*TOLEDO CITY
PLAN COMMISSION
REPORT*

September 10, 2015

**TOLEDO-LUCAS COUNTY PLAN COMMISSIONS
APPLICATION DEADLINE, AGENDA, STAFF REPORT AND HEARING
SCHEDULE - 2015**

PRELIMINARY DRAWING
OF
Heather Cove
A PLANNED UNIT DEVELOPMENT
CITY OF TOLEDO, LUCAS COUNTY, OHIO

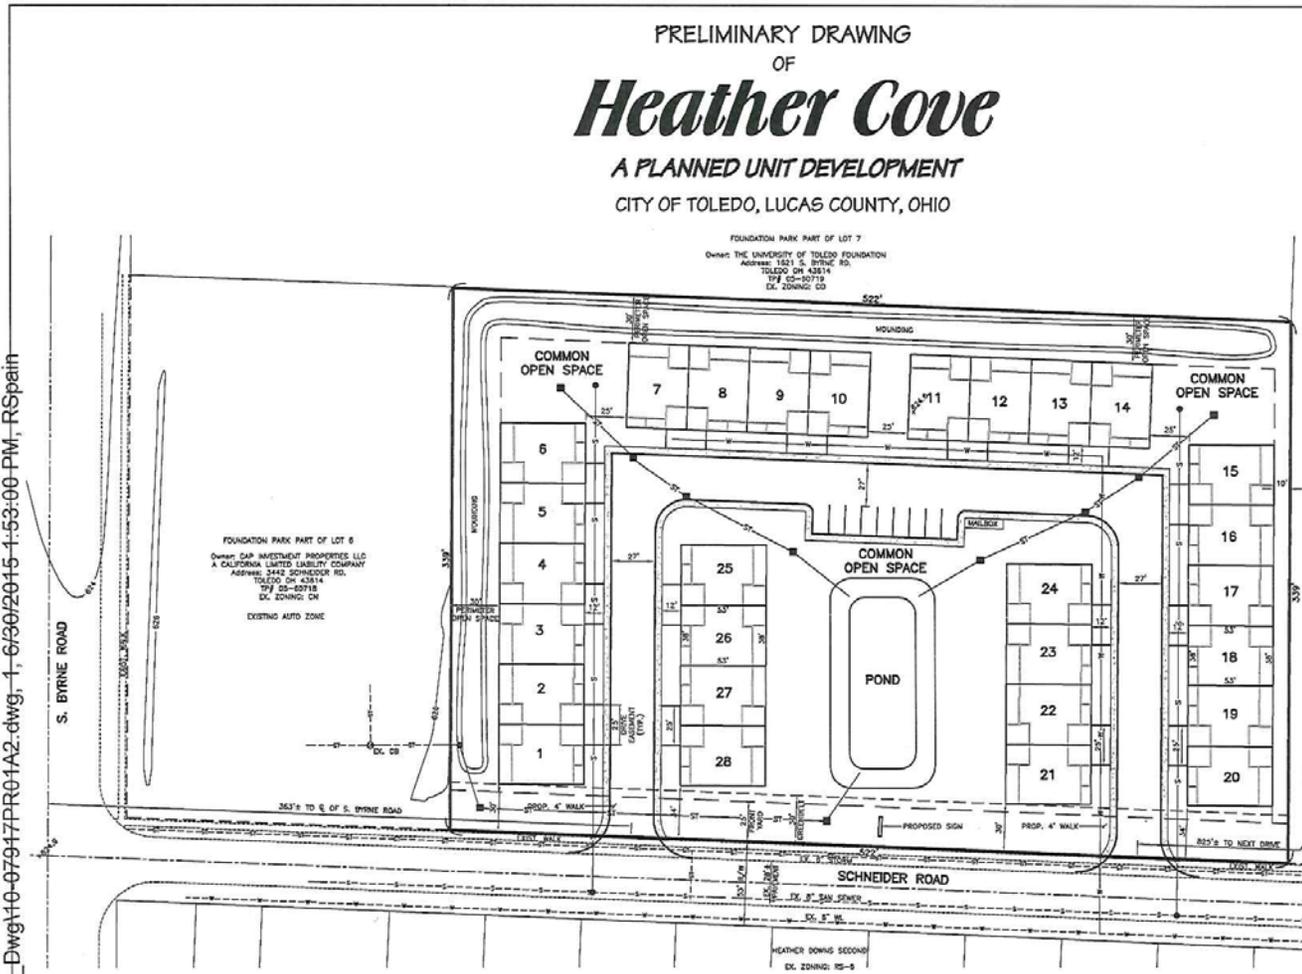
The applicant is proposing to access the site via a private street from Schneider Road. Pursuant to the City of Toledo Subdivision Regulations, private streets are generally discouraged in all subdivisions because of the long term maintenance liability and the various concerns with private ownership. However, recognizing unique development issues with smaller parcels and innovative subdivision designs, the Toledo City Plan Commission may at their discretion allow private streets. Staff has determined that due to the configuration and the small size of development, unique circumstances exist and supports the use of a private street. In addition, a two foot (2') anti vehicular buffer exists on the plat and will need to be removed prior to final approval.

14. Plans show a connection to a private storm sewer on the west side of the property. The City of Toledo cannot approve plans or give permission to use this storm line without a written agreement and maintenance plan between the two property owners. Suggest connecting into an existing structure or installing a new structure on the existing public storm sewer that runs parallel to the property along Schneider Road.

27. Need to show current owners name on Preliminary Drawing. The applicant will need to follow all current platting rules and regulations..

44. A thirty foot (30') perimeter open space area is required along the northern and western property lines.
45. A Final Plat shall not be approved unless the pending Zone Change to RM12 and PUD are approved by the City of Toledo.
46. No permits shall be issued until arrangements satisfactory to the Director of the City of Toledo Plan Commission have been made for compliance with the conditions as set forth above.
47. The Preliminary Drawing shall be valid for a three (3) year period from the date of approval by the Planning Commission.
